Access Compliance Report

Public Rights-of-Way

(Curb Ramps)

Intersection ID: 43839	Main Street: DELUCA_DR	Cross Street: HAMEL_ST	Location: NE
ADA ID: E7D6F362361A	Ramp Type: BlendTrans1	Initial Pass/Fail: Fail	Overall Compliance: No
Severity Score: 8.75			
Codes/Mitigation Info/Possible Solution		Field Measurements/Component Compliance

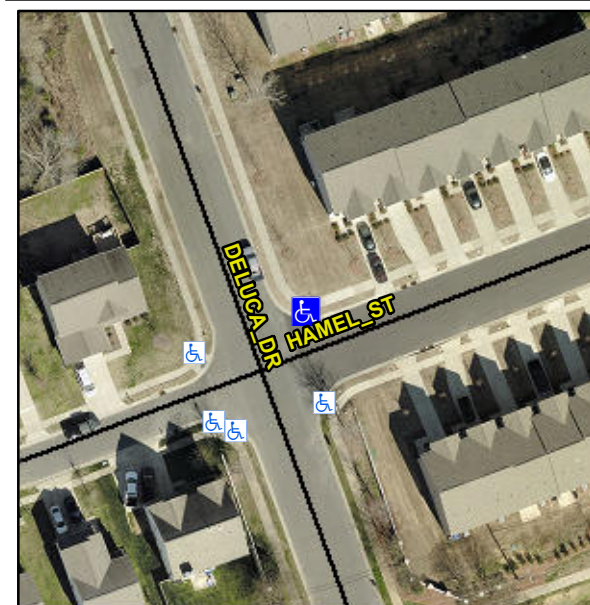
CURB GAP 1.0

Not Found, R304.5.1

Compliance	Description	Data	Compliance	Description	Data
N/A	Ramp Length (in)	48.0	Yes	BlendTrans Slope (%)	4.4
No	Ramp Width (in)	47.0	Yes	BlendTrans XSlope (%)	0.7
N/A	Flare Type LT	N/A	N/A	Flare Type RT	N/A
N/A	Flare Slope LT (%)	N/A	N/A	Flare Slope RT (%)	N/A
N/A	Flare Traversable LT?	N/A	N/A	Flare Traversable RT?	N/A
N/A	Landing Length (in)	N/A	N/A	DWS Provided?	N/A
N/A	Landing Width (in)	N/A	N/A	DWS Contrast?	N/A
N/A	Landing Slope (%)	N/A	N/A	DWS Length (in)	N/A
N/A	Landing X Slope (%)	N/A	N/A	DWS Full Width?	N/A
N/A	Landing Curb? (Y/N)	N/A	N/A	DWS Offset (in)	N/A
N/A	Shared Landing?	N/A			
N/A	Gutter Ponding?	N/A	N/A	Gutter Slope (%)	N/A
N/A	Gutter Lip Ht (in)	N/A	N/A	Gutter X Slope (%)	N/A
N/A	Painted X Walk1?	No	N/A	Painted X Walk2?	No
	X Walk 1 Direction	To W		X Walk 2 Direction	To S
	X Walk 1 Width (in)	N/A		X Walk 2 Width (in)	N/A
	X Walk 1 Slope (%)	1.1		X Walk 2 Slope (%)	3.3
	X Walk 1 X Slope (%)	5.4		X Walk 2 X Slope (%)	2.4

N/A	Ramp inside XWalk1?	N/A	N/A	Ramp inside XWalk2?	N/A
	Road Slope (%)	0.2		Clear Space?	N/A
	Road X Slope (%)	1.3	N/A	Clear Space to XWalk (in)	N/A
N/A	Any Obstructions?	N/A	N/A	Storm Grate/Utility Hazard?	N/A
	Obstruction Type			Storm Grate/Utility Type	
		N/A			N/A
			Yes	Surface Condition? (G/P)	Good
			No	Curb Slope (%)	12.3

Remove & Replace Curb Ramp With Two New Directional Ramps or Equivalent.
